# Access Compliance Report

## Public Rights-of-Way

### (Curb Ramps)

Intersection ID: 10024504	Main Street: CRUMP_RD	Cross Street: N/A	Location: SW
ADA ID: 2DD21B7517CC	Ramp Type: Perp	Initial Pass/Fail: Fail	Overall Compliance: No
Codes/Mitigation Info/Possible Solution		Field Measurements/Component Compliance	
Severity Score: 12.5

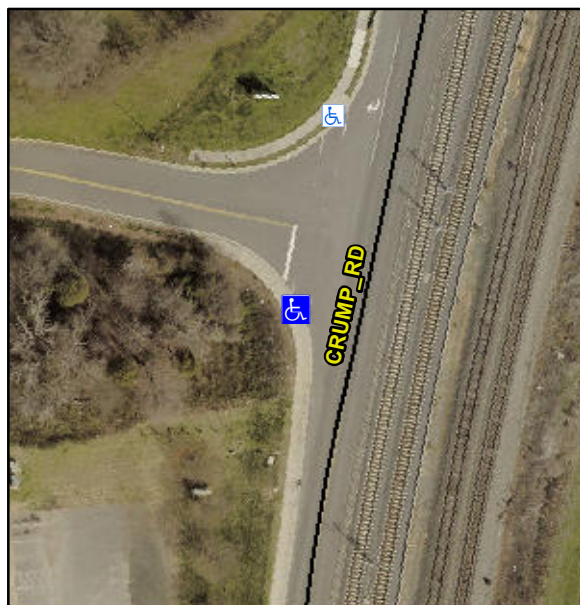
**Not Found, R304.2.2**

Compliance	Description	Data	Compliance	Description	Data
N/A	Ramp Length (in)	72.0	No	Ramp Slope (%)	8.4
Yes	Ramp Width (in)	57.0	Yes	Ramp XSlope (%)	0.8
N/A	Flare Type LT	N/A	N/A	Flare Type RT	N/A
N/A	Flare Slope LT (%)	N/A	N/A	Flare Slope RT (%)	N/A
N/A	Flare Traversable LT?	N/A	N/A	Flare Traversable RT?	N/A
N/A	Landing Length (in)	N/A	N/A	DWS Provided?	N/A
N/A	Landing Width (in)	N/A	N/A	DWS Contrast?	N/A
N/A	Landing Slope (%)	N/A	N/A	DWS Length (in)	N/A
N/A	Landing X Slope (%)	N/A	N/A	DWS Full Width?	N/A
N/A	Landing Curb? (Y/N)	N/A	N/A	DWS Offset (in)	N/A
N/A	Shared Landing?	N/A			
N/A	Gutter Ponding?	N/A	N/A	Gutter Slope (%)	N/A
N/A	Gutter Lip Ht (in)	N/A	N/A	Gutter X Slope (%)	N/A
N/A	Painted X Walk1?	Yes	N/A	Painted X Walk2?	N/A
	X Walk 1 Direction	To NE		X Walk 2 Direction	N/A
N/A	X Walk 1 Width (in)	112.0	N/A	X Walk 2 Width (in)	N/A
	X Walk 1 Slope (%)	0.0		X Walk 2 Slope (%)	N/A
	X Walk 1 X Slope (%)	3.4		X Walk 2 X Slope (%)	N/A

**Remove & Replace Entire Ramp.**
